12.4.1 PLANNING APPLICATION FOR HOUSE AND OVERSIZED SHED AT LOT 3325 SCAFFIDI PLACE, DONNYBROOK

Location:	Lot 3325 Scaffidi Place, Donnybrook
Applicants:	Mr Matt Ramponi
Zone:	Rural Residential
File Ref:	A4882
Author:	Bob Wallin - Principal Planner
Report Date:	29 August 2017
Attachments:	12.4.1(1) – Site Plan 12.4.1(2) – Superimposed Image of Site 12.4.1(3) – Reoriented Site Plan

ATTACHMENT 12.4.1(2)

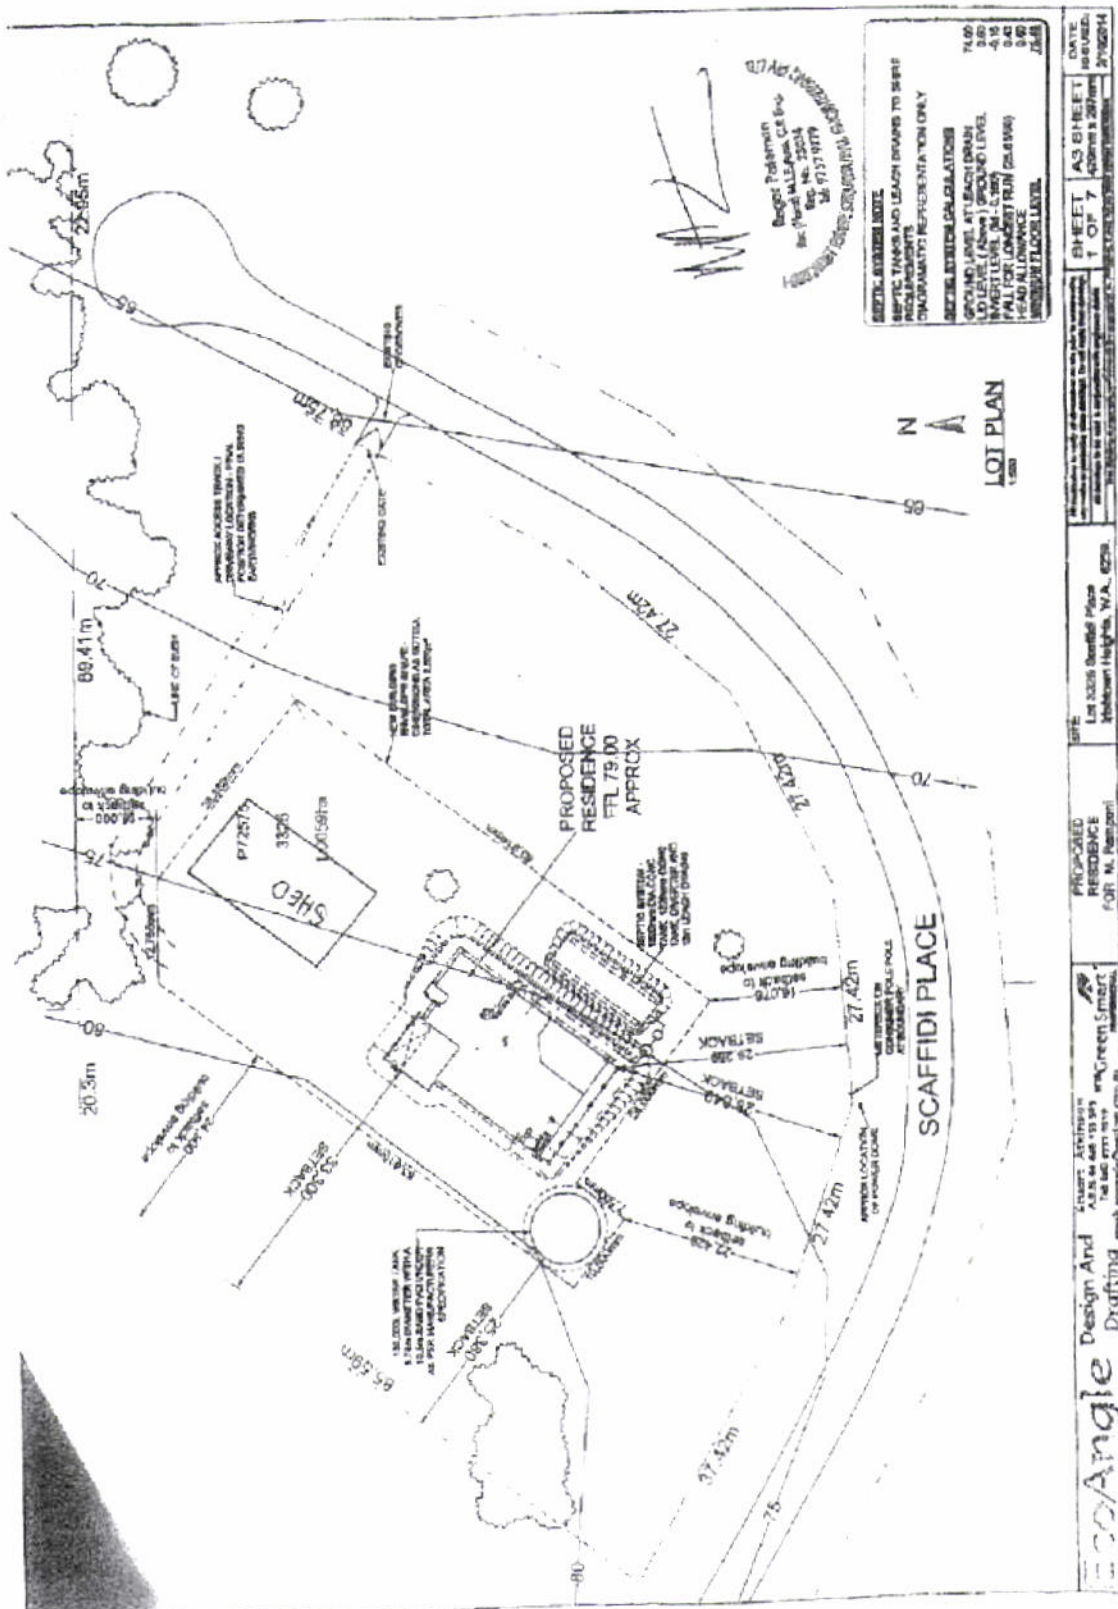
The proposed shed represents a variation on the policy by 30% for the floor area and 12% for the wall height. The shed will be located on a cleared hill that sits approximately 15m above the road level. A building pad has been established. The earth works consist of a 3 metre high pad (approximate) with steep sloping sides. Attachment 12.4.1(2) provides a super imposed image of how the shed will look from the road.

In the immediate locality to the west, south and east consists of vacant Rural Residential lots. Land to the north is currently vegetated and has potential for future Rural Residential subdivision. The shed will front Scaffidi Place where it nears a cul-de-sac. It is noted that current planning shows that this cul-de-sac will eventually turn into a through road linking to Irishtown Road. The shed, due to its prominent location on the site will be highly visible and impact on vistas.

The additional wall height, when considered in combination with the floor area variation of 30% (55m²) and elevated position on the lot, the result will be a structure having a bulk far larger than intended for the zone.

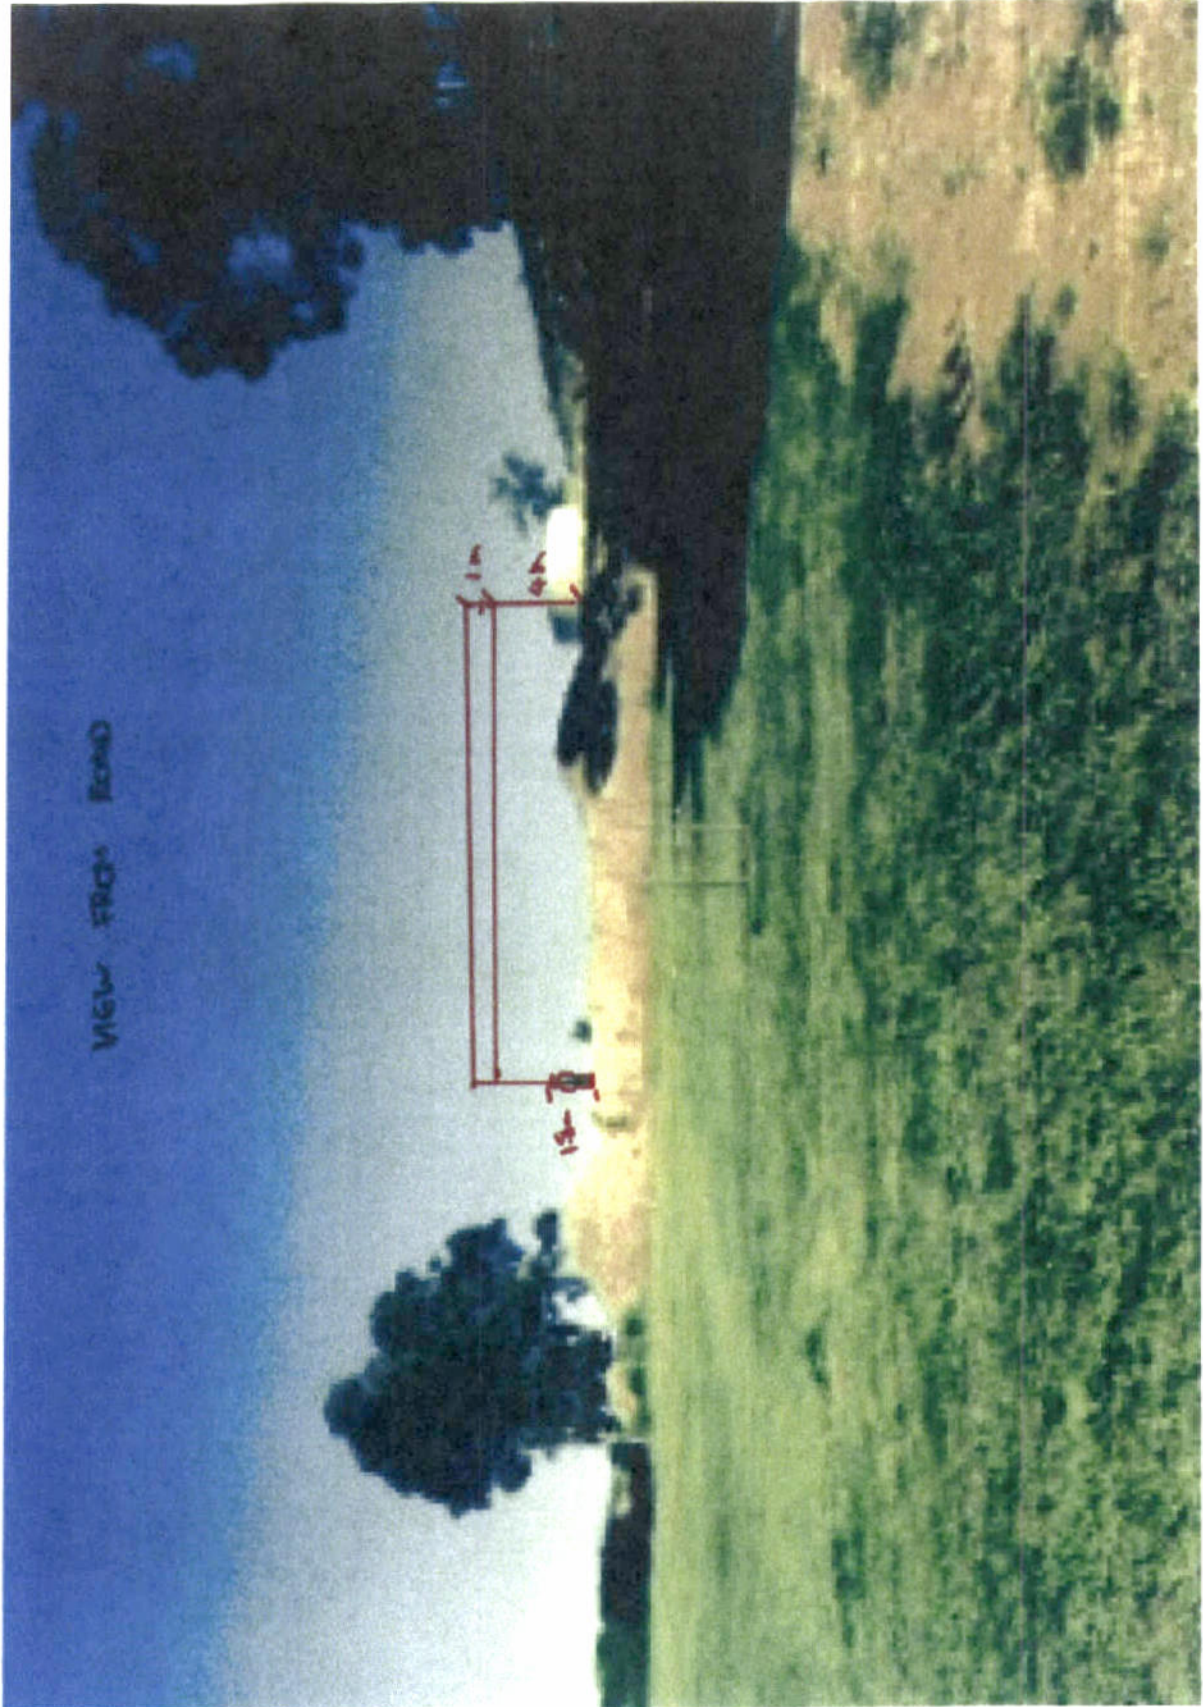
The impact of sheds can be reduced through landscape treatments and building orientation. In this case, there is potential to reduce the bulk of the built form from the public realm by re-orientating the shed so that the 11.8m frontage faces the street (Attachment 12.4.1(3)). This will effectively reduce the impact of the shed bulk to be more in line with other sheds in the estate. Visibility of the shed from other elevations is addressed as follows:

The applicant raises no objections to this alternative solution.
